Access Compliance Report

Public Rights-of-Way

(Curb Ramps)

Intersection ID: 44850	Main Street: STEELE_CREEK_RD	Cross Street: SHOPTON_RD_WEST	Location: NW
ADA ID: 14FD73E143AB	Ramp Type: Perp	Initial Pass/Fail: Fail	Overall Compliance: No
Severity Score: 8.75			
Codes/Mitigation Info/Possible Solution		Field Measurements/Component Compliance

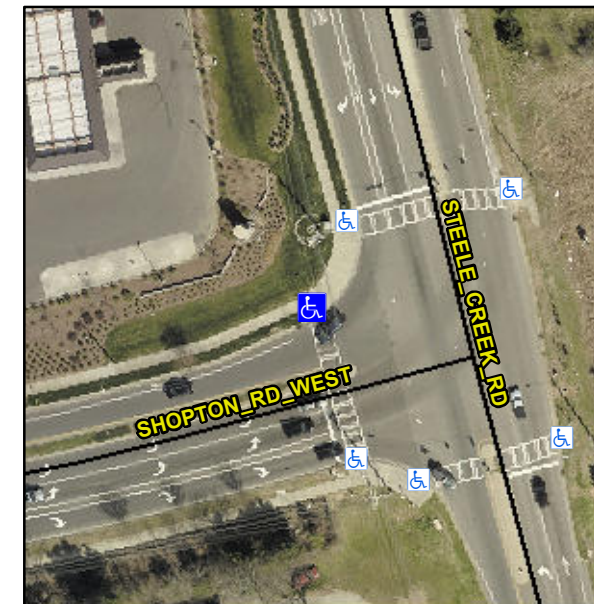
Not Found, R304.5.1

Compliance	Description	Data	Compliance	Description	Data
N/A	Ramp Length (in)	72.0	Yes	Ramp Slope (%)	8.3
No	Ramp Width (in)	38.0	Yes	Ramp XSlope (%)	1.2
N/A	Flare Type LT	N/A	N/A	Flare Type RT	N/A
N/A	Flare Slope LT (%)	N/A	N/A	Flare Slope RT (%)	N/A
N/A	Flare Traversable LT?	N/A	N/A	Flare Traversable RT?	N/A
N/A	Landing Length (in)	N/A	N/A	DWS Provided?	N/A
N/A	Landing Width (in)	N/A	N/A	DWS Contrast?	N/A
N/A	Landing Slope (%)	N/A	N/A	DWS Length (in)	N/A
N/A	Landing X Slope (%)	N/A	N/A	DWS Full Width?	N/A
N/A	Landing Curb? (Y/N)	N/A	N/A	DWS Offset (in)	N/A
N/A	Shared Landing?	N/A			
N/A	Gutter Ponding?	N/A	N/A	Gutter Slope (%)	N/A
N/A	Gutter Lip Ht (in)	N/A	N/A	Gutter X Slope (%)	N/A
N/A	Painted X Walk1?	Yes	N/A	Painted X Walk2?	N/A
	X Walk 1 Direction	To S		X Walk 2 Direction	N/A
N/A	X Walk 1 Width (in)	112.0	N/A	X Walk 2 Width (in)	N/A
	X Walk 1 Slope (%)	3.8		X Walk 2 Slope (%)	N/A
	X Walk 1 X Slope (%)	3.4		X Walk 2 X Slope (%)	N/A

N/A	Ramp inside XWalk1?	Yes	N/A	Ramp inside XWalk2?	N/A
	Road Slope (%)	N/A	N/A	Clear Space?	N/A
	Road X Slope (%)	N/A	N/A	Clear Space to XWalk (in)	N/A
N/A	Any Obstructions?	N/A	N/A	Storm Grate/Utility Hazard?	N/A
	Obstruction Type			Storm Grate/Utility Type	
		N/A			N/A
		Yes		Surface Condition? (G/P)	Good

Remove & Replace Entire Ramp.
